REMARKS

FIG. 14B

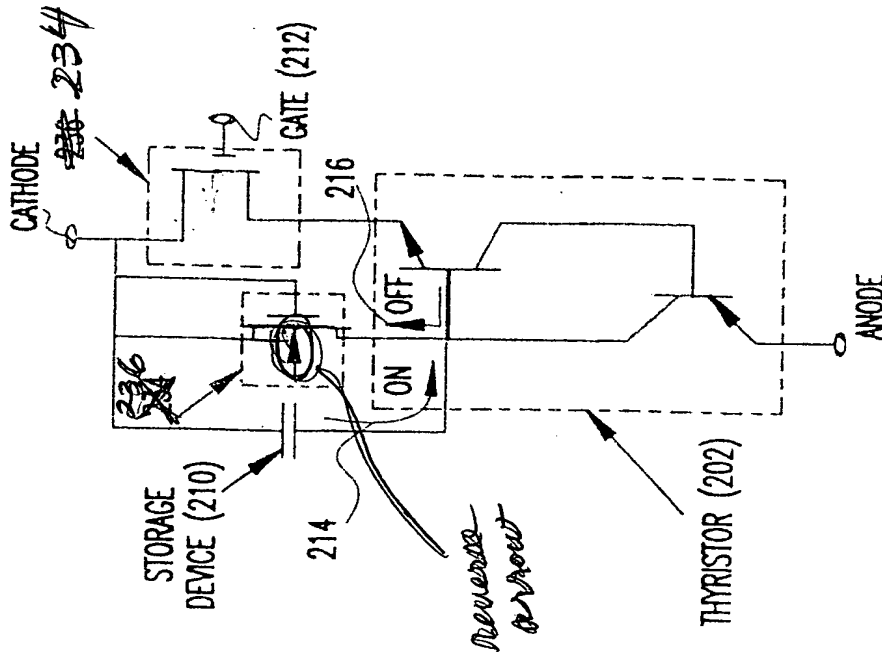
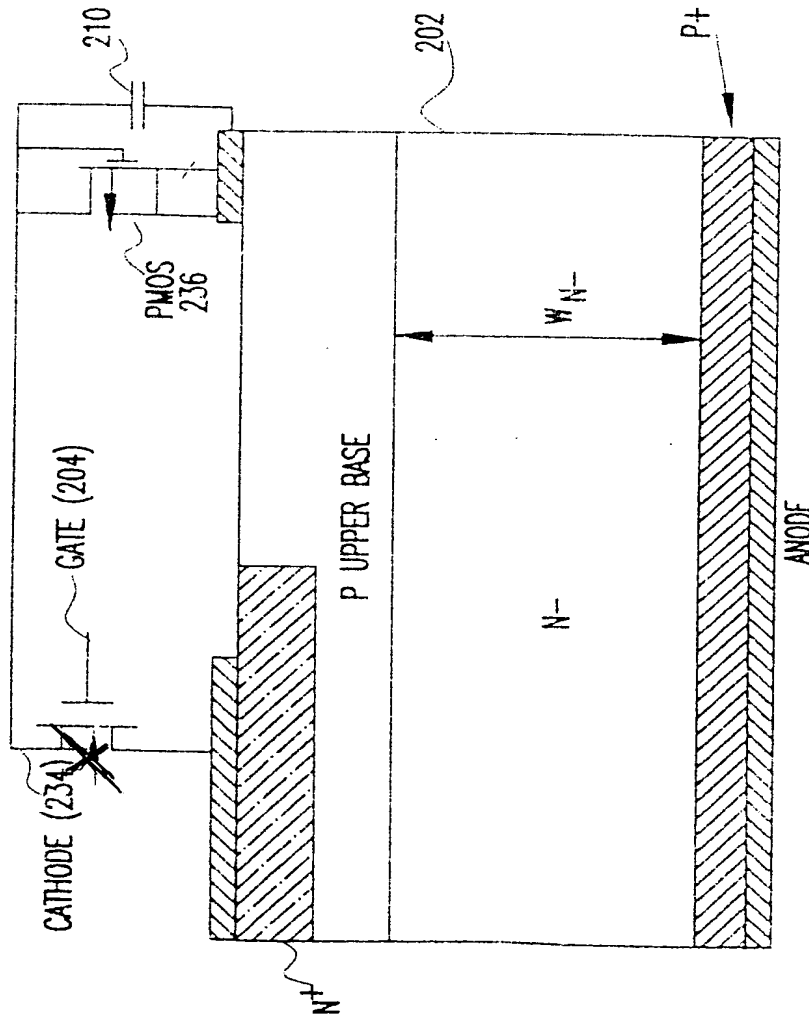
The Examiner has objected to the formal drawings submitted on February 26, 2004; the Examiner making specific criticisms of Figures 3A, 14A - 14 B and 17A - 17B and raising questions in regard to the depictions of Figures 18 and 19. This objection is respectfully traversed as moot in view of the amendments made above and the concurrently filed replacement drawing sheets.

In regard to Figures 14A and 14B, upon review in light of the Examiner's criticisms, it was discovered that reference numerals 234 and 236 were reversed in Figure 14B as originally filed, as compared with Figure 14A. This revision can be verified by comparison to Figures 13A and 13B since Figures 14A and 14B are disclosed in the paragraph bridging pages 19 and 20 are similar to the circuit/device of Figures 13A and 13B but substituting PMOS transistors for NMOS transistors. Accordingly, approval has been requested, above, for an appropriate correction. The depiction of transistors

234 and 236 has been previously approved and such revisions have been made in regard to the depictions of the transistors as correctly identified and in a manner consistent between Figures 14A and 14B.
